Re: Waffle House – Development Plan Application # 201608290059
2928 London-Groveport Road
Grove City, Ohio

Following is the disposition to first review comments (dated 9/16/2016) for the referenced project:

PROPOSED WAFFLE HOUSE - DUMPSTER

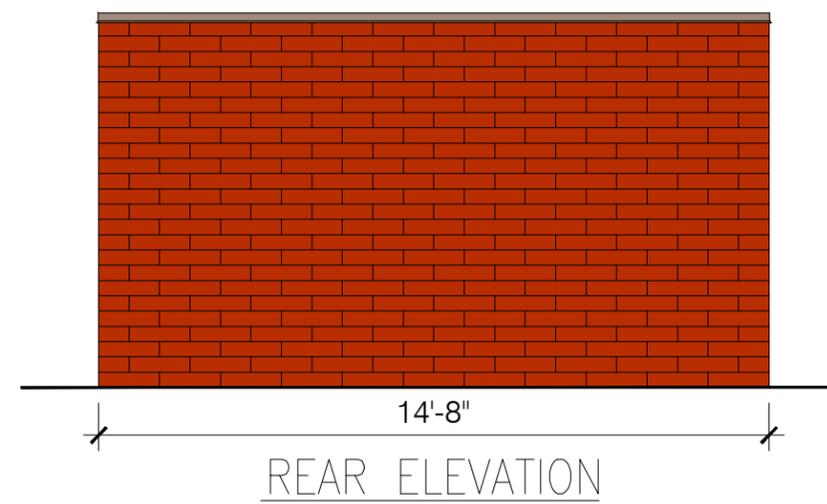
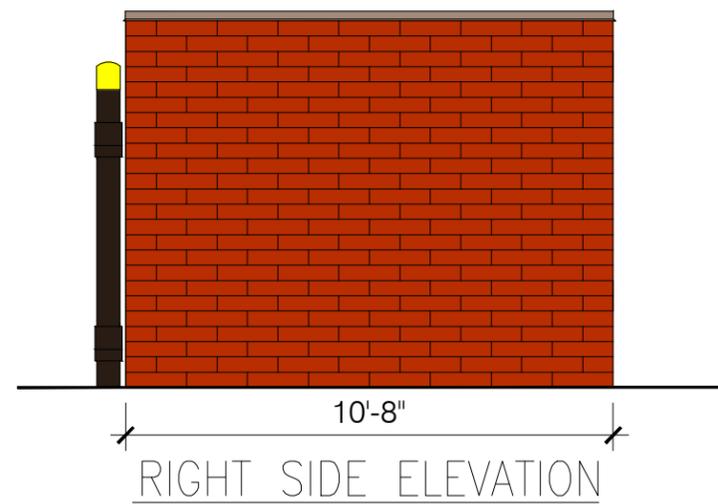
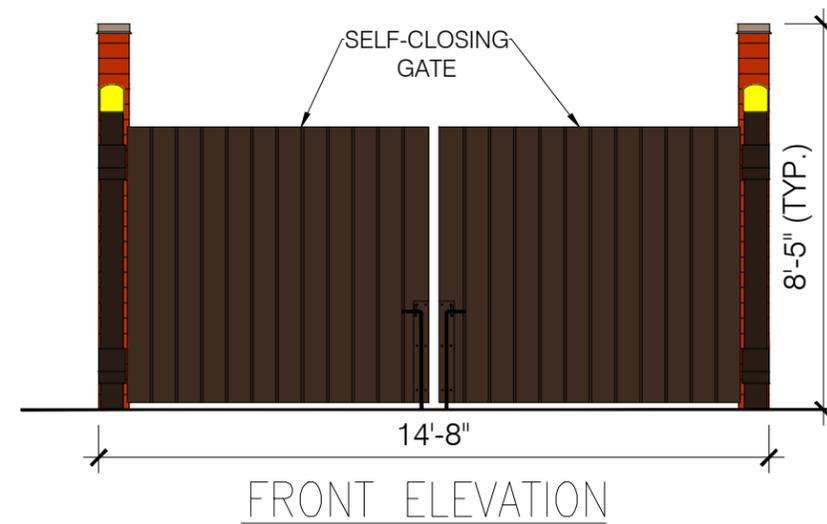
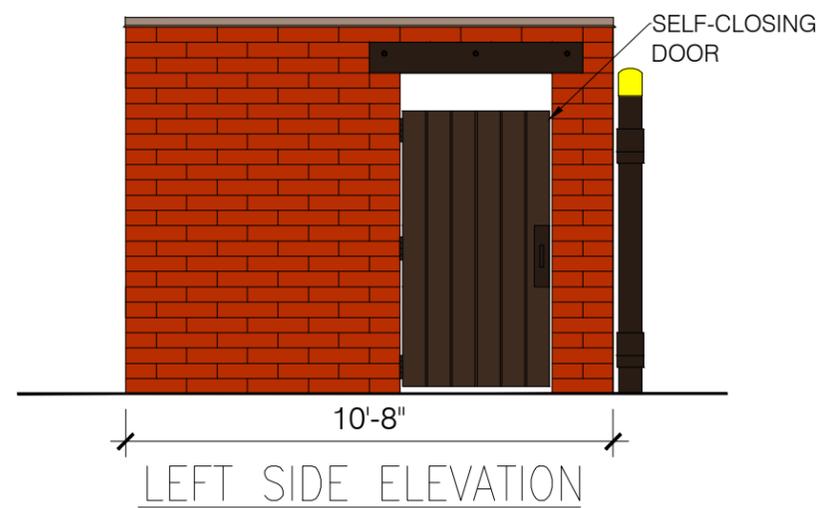
13. Screening is required around all sides of the dumpster. The opening on the left side of the dumpster will need to be enclosed as well.

14. The proposed metal dumpster gates should be replaced with stained wood gates.

Response: The dumpster will be screened on all sides: three sides will be brick, with the remaining side consisting of a gate. The side access door will have a gate. The trash enclosure rendering is included in this submittal.

Response: Complied.
